Project
East West Rail (Western Section) Phase 2

Drawing Title
JUNCTION IMPROVEMENT A3_J_2 GENERAL ARRANGEMENT

Stage 2 Road safety audit response report

Offline Highways – Compound Accesses and Junctions – Oxfordshire (A1 Bicester Road Compound Access), (A2 Station Road Compound Access), (A3_J_2 Stratton Audley Park Junction Improvement), (A2_J_9 Mill Road Junction Improvement)

East West Rail (Western Section) Phase 2
JUNCTION IMPROVEMENT A3_J_2 SITE CLEARANCE

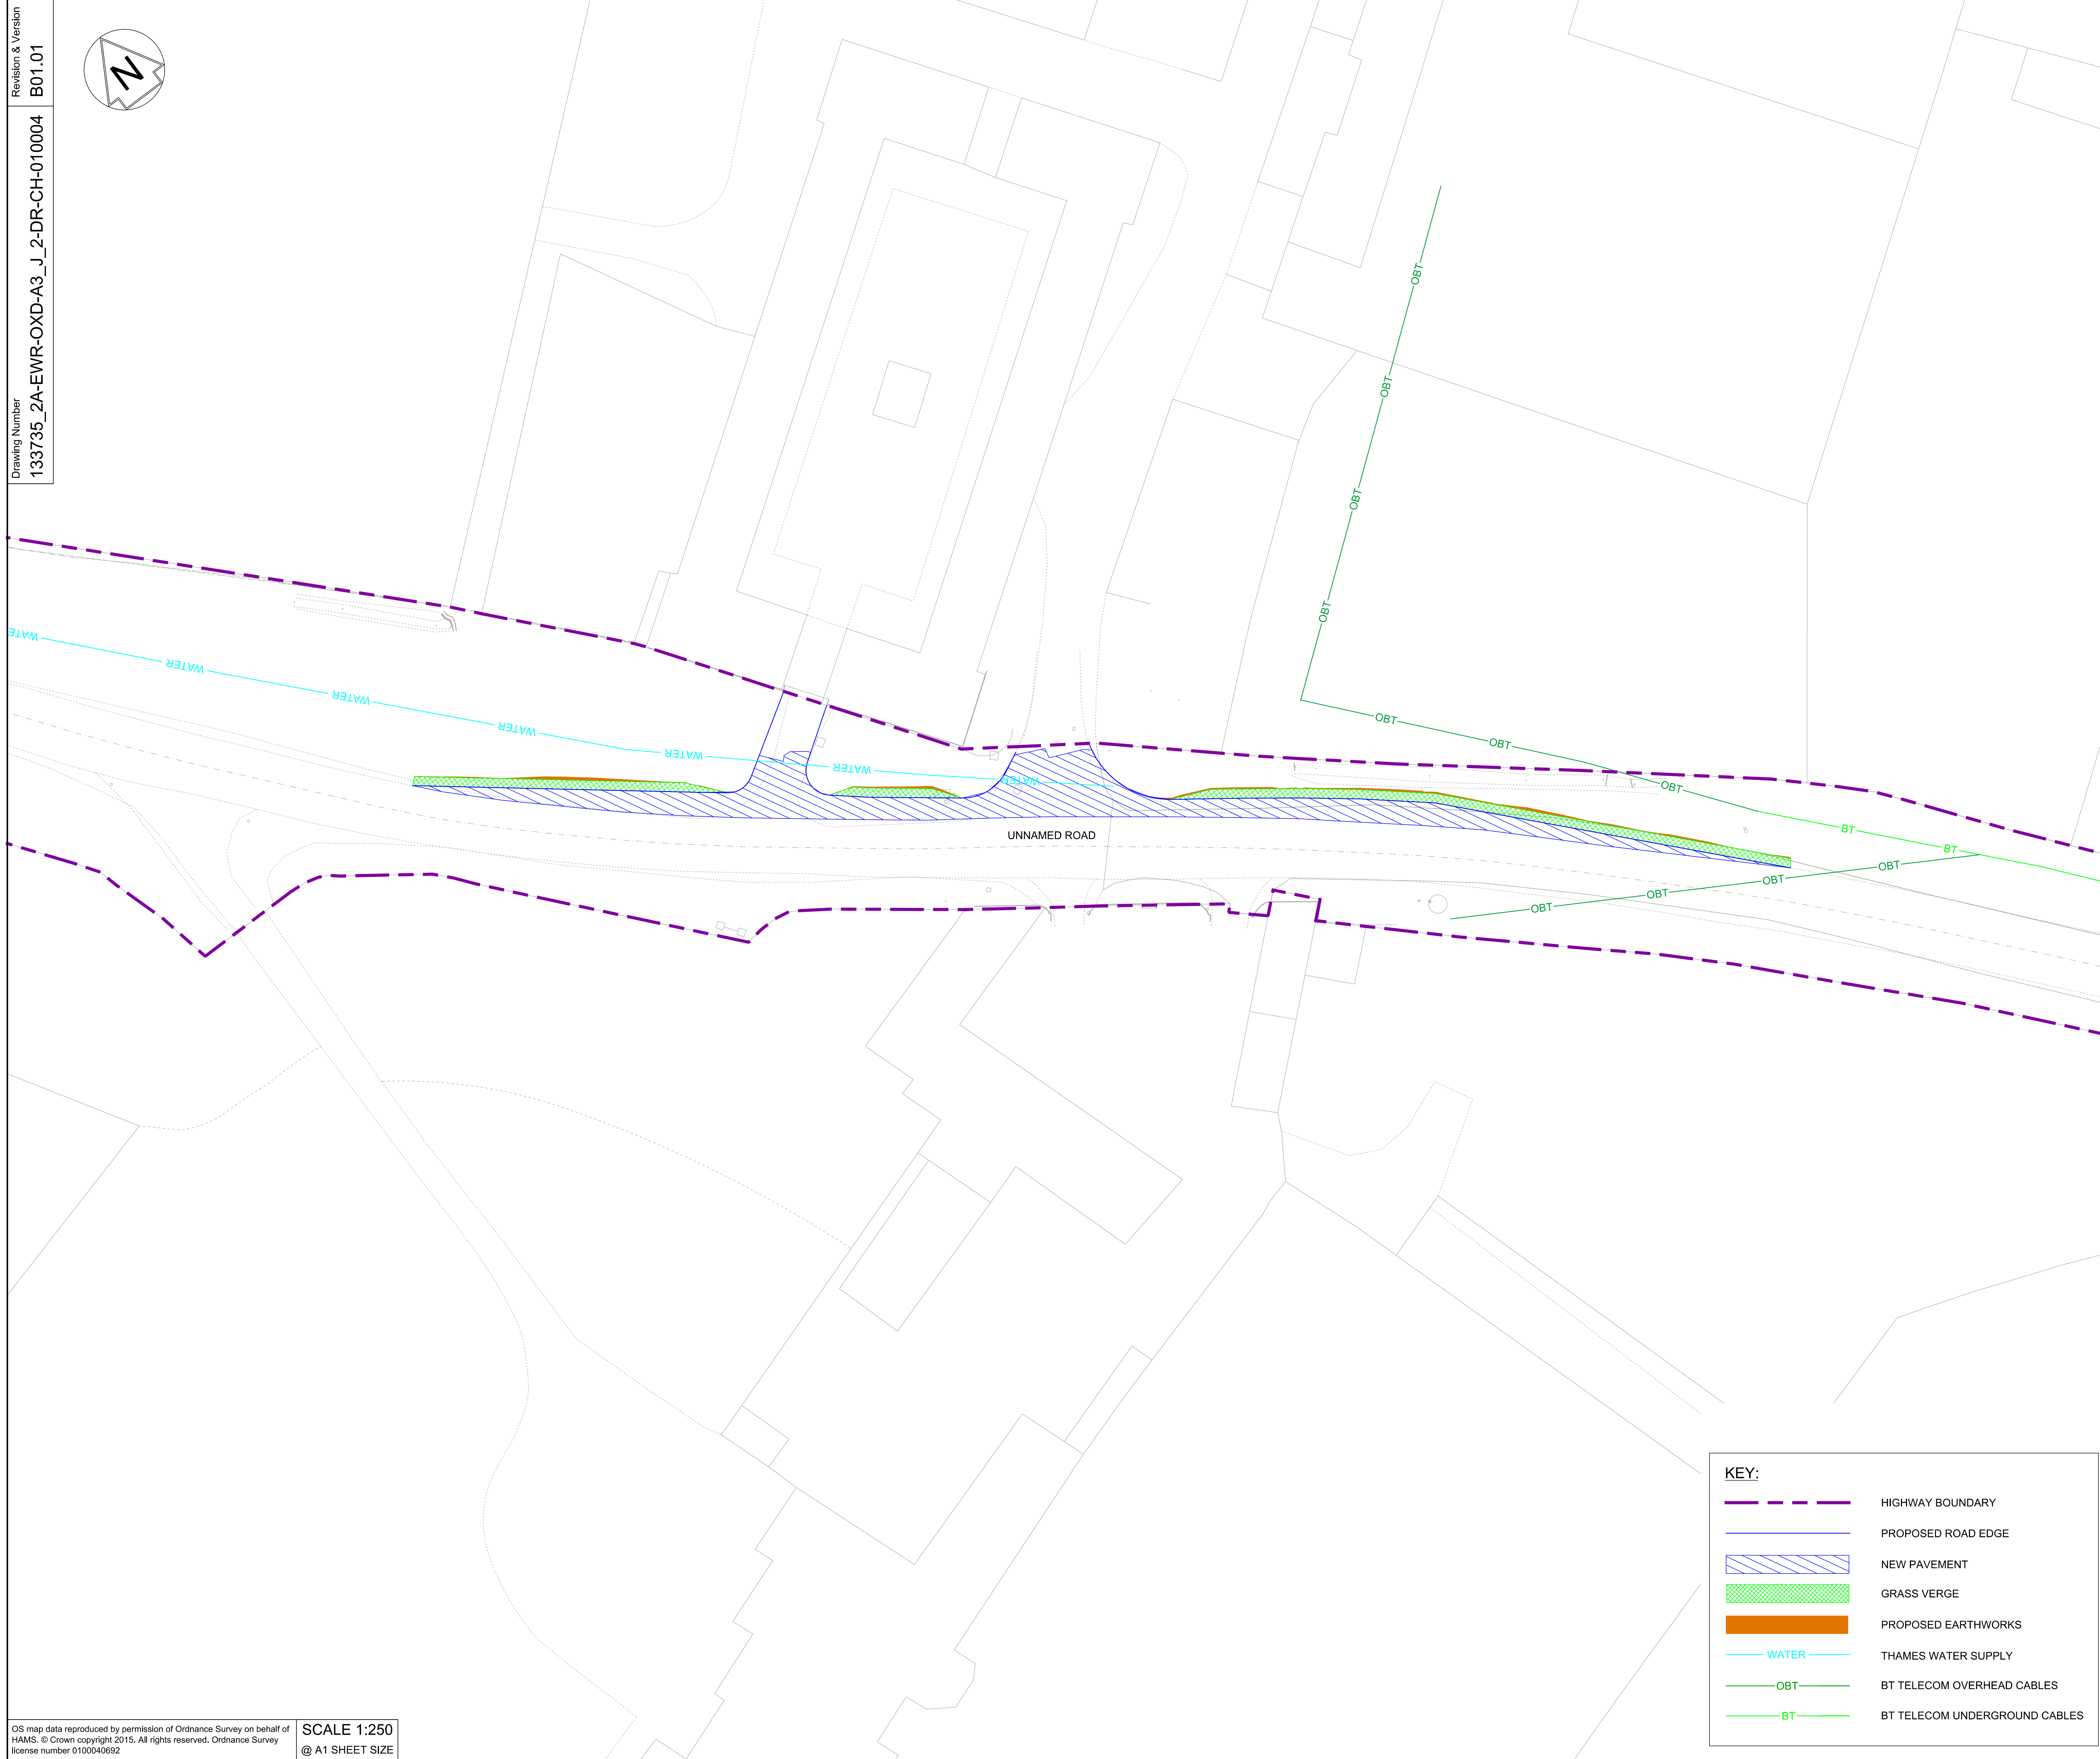
Summary: Overhanging vegetation could obstruct road users, damage vehicles, and increase the risk of collisions or injury occurring

It is unclear from the drawings provided to audit the extent of vegetation clearance proposed. Existing vegetation overhanging an area where carriageway widening is proposed may damage passing vehicles, cause branches to fall in the carriageway (forming an obstruction in the carriageway), or force opposing traffic flows together (through evasive manoeuvres) increasing the risk of head on collisions or side swipes.

RECOMMENDATION

It is recommended that adequate vegetation is cleared to ensure vehicles can pass along the carriageway safely.

2.3	Site Compound, A3_J_2- Unnamed Road.	<p>Overhanging vegetation could obstruct road users, damage vehicles, and increase the risk of collisions or injury occurring</p> <p>It is unclear from the drawings provided to audit the extent of vegetation clearance proposed. Existing vegetation overhanging an area where carriageway widening is proposed may damage passing vehicles, cause branches to fall in the carriageway (forming an obstruction in the carriageway), or force opposing traffic flows together (through evasive manoeuvres) increasing the risk of head on collisions or side swipes.</p>	It is recommended that adequate vegetation is cleared to ensure vehicles can pass along the carriageway safely.	<p>Accept the RSA problem and recommendation made by the RSA team.</p> <p>The site clearance drawings note that vegetation clearance shall be undertaken to provide suitable visibility.</p>	Accepted	Proceed as Design Team Response
